Subject: Response to the Referenced Technical Incompleteness Determination, Waste Isolation Pilot Plant Hazardous Waste Facility Permit Number: NM4890139088-TSDF

Reference: New Mexico Environment Department correspondence from Stephanie Stringer, Director, Resource Protection Division, to Kirk Lachman, Acting Manager, and Sean Dunagan, President and Project Manager, dated December 6, 2019; subject: Technical Incompleteness Determination of Class 3 Modification, Excavation of a New Shaft and Associated Connecting Drifts, Waste Isolation Pilot Plant, EPA I.D. Number NM4890139088

Enclosure 1
Response to Comments

Figure 1: Shaft Collar Plan View

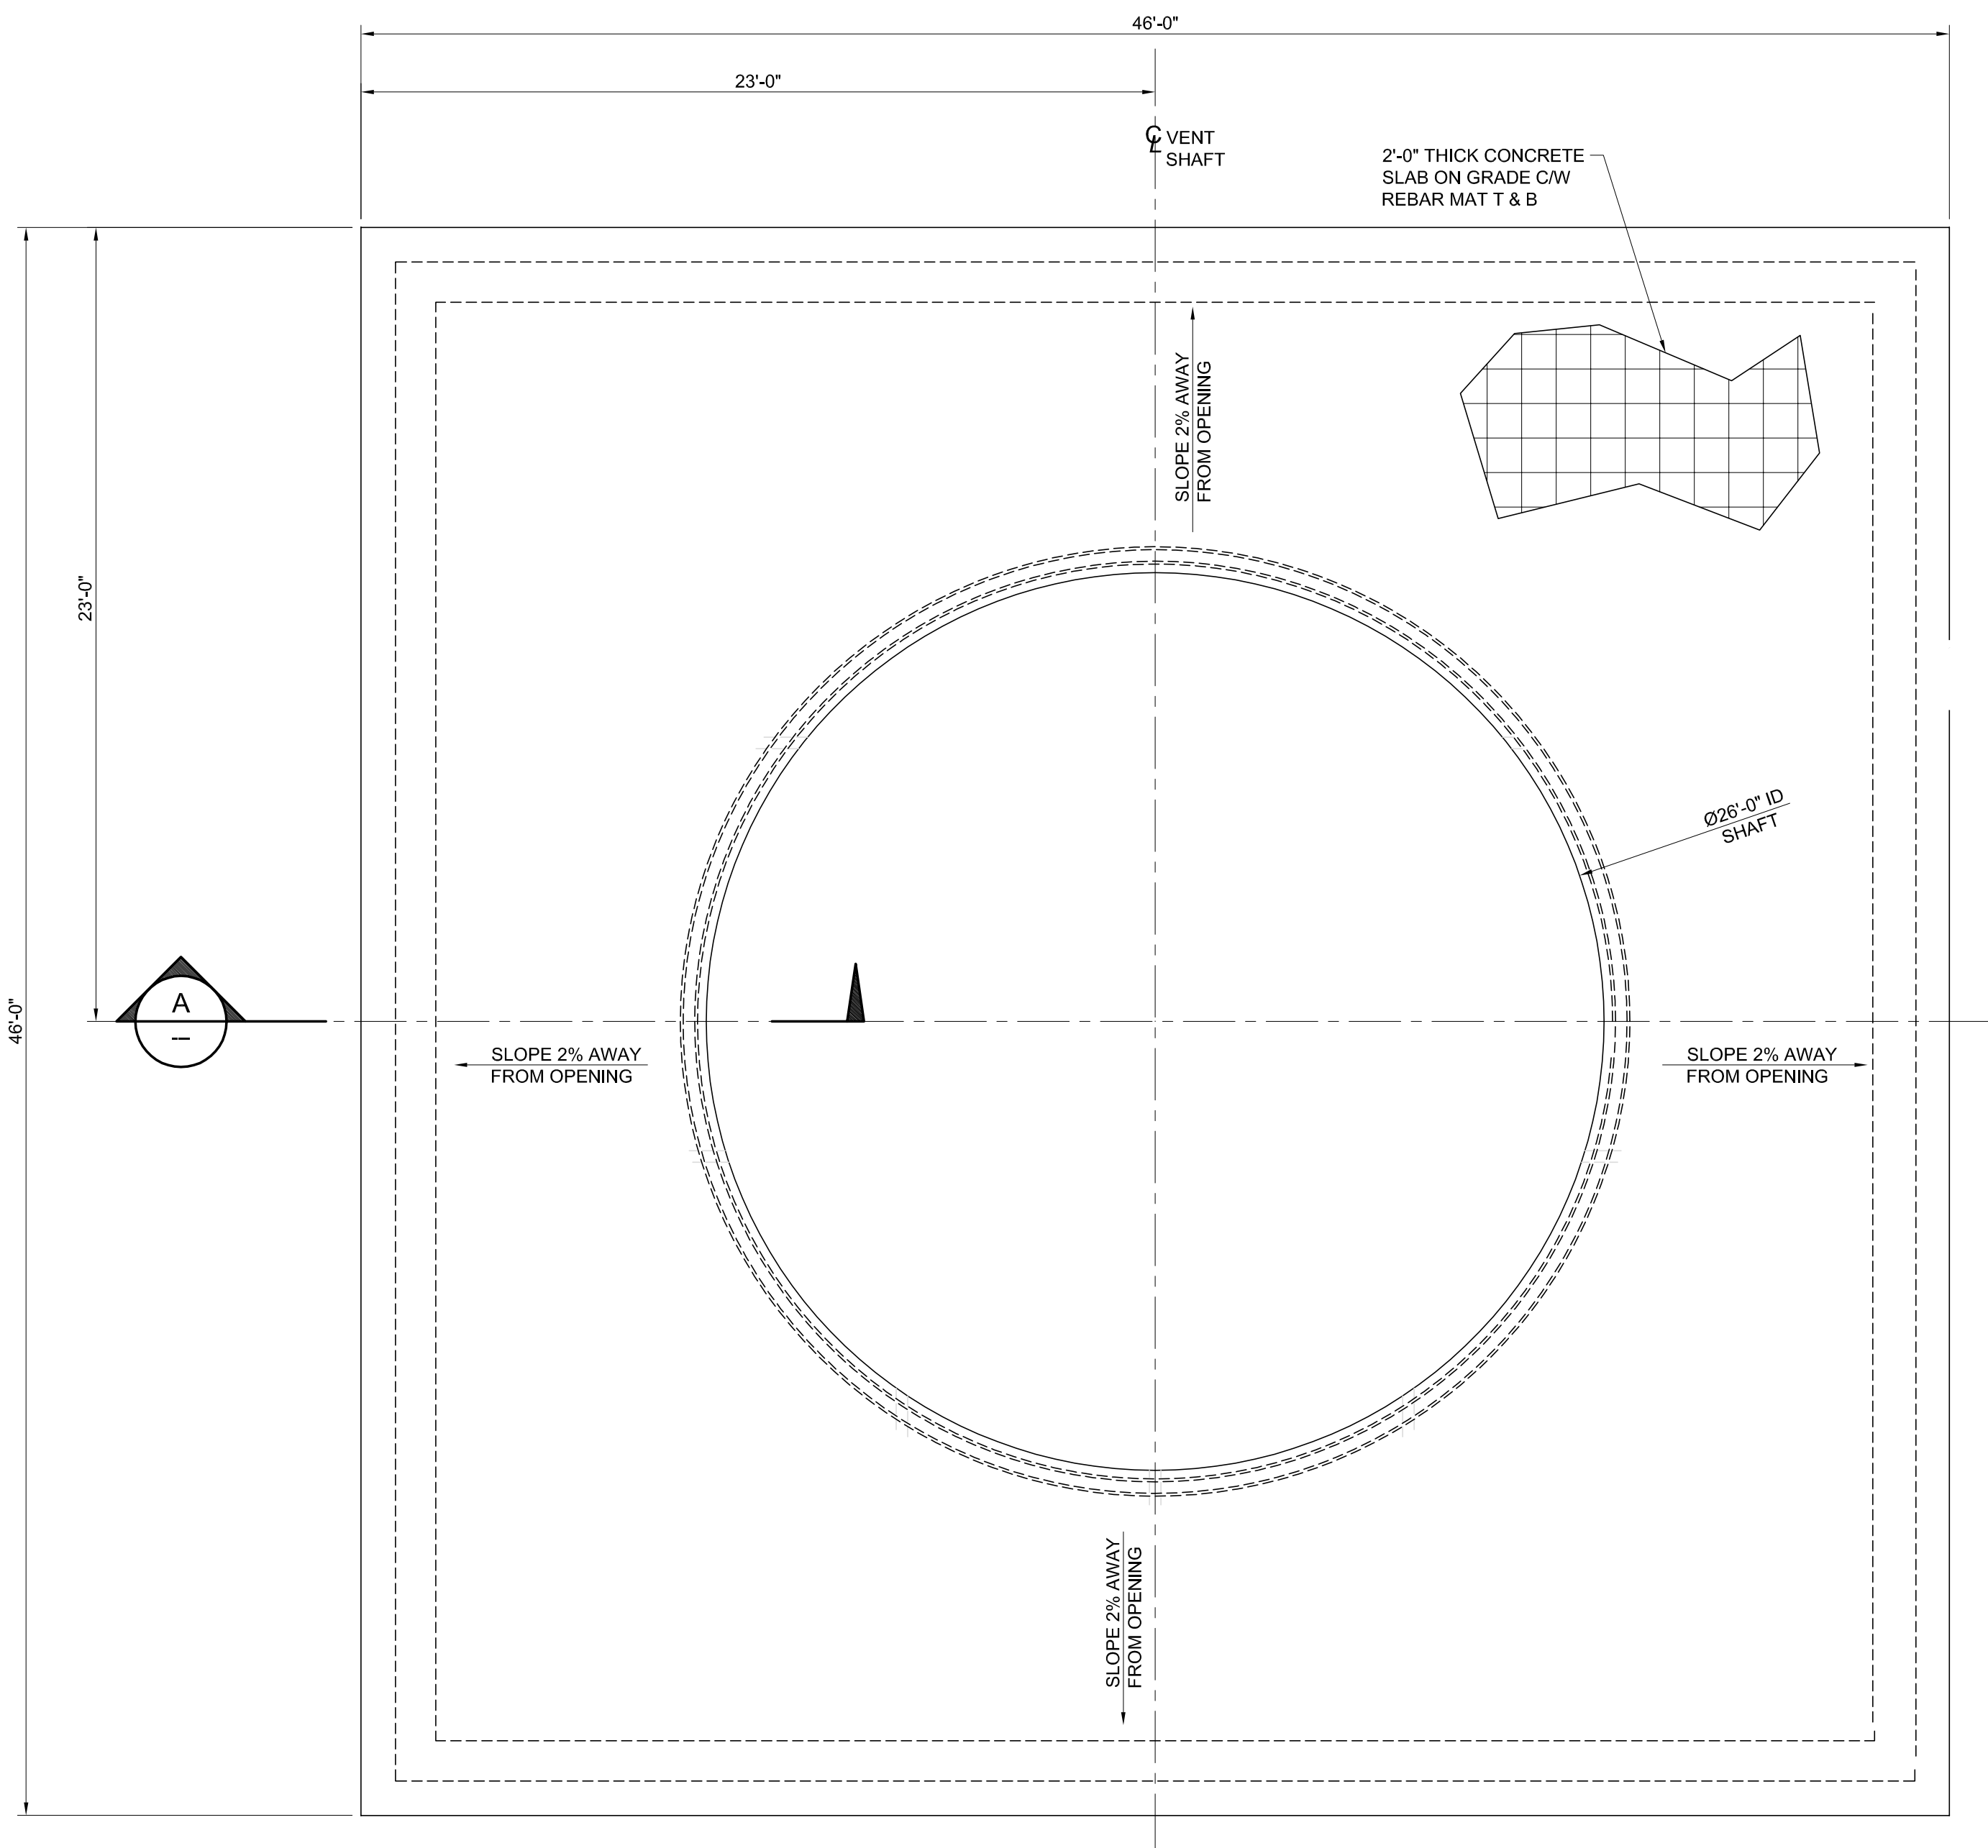
8. **Surface Water Control System:** Please provide details demonstrating that control systems for surface water run-on/run-off at the surface location of the new shaft will provide adequate protection from flooding.

RESPONSE: Figures 1 and 2 are included as Enclosure 3. Figure 1 shows the concrete reinforcement plan for the collar/pre-sink. Figure 2 shows a cross section of the main plan view. For shaft sinking purposes, the top of the collar (top of the concrete) is considered to be the starting elevation of zero feet. The depth of the shaft is described in feet from the top of the collar (i.e., the 100-foot mark in the shaft is 100 feet down in the shaft, measured from the top of the collar). The actual surface elevation of the top of the collar is 3,401.5 feet as shown on the drawing. The drawing shows that the grade, or surface of the land that the collar is set on, is 3,400.0 feet. The collar is 1.5 feet higher than the ground surface at this location. The shaft collar slopes away from the shaft opening at a 2% grade. The 2% grade will cause water or rainfall near the shaft opening to flow away from the shaft opening.
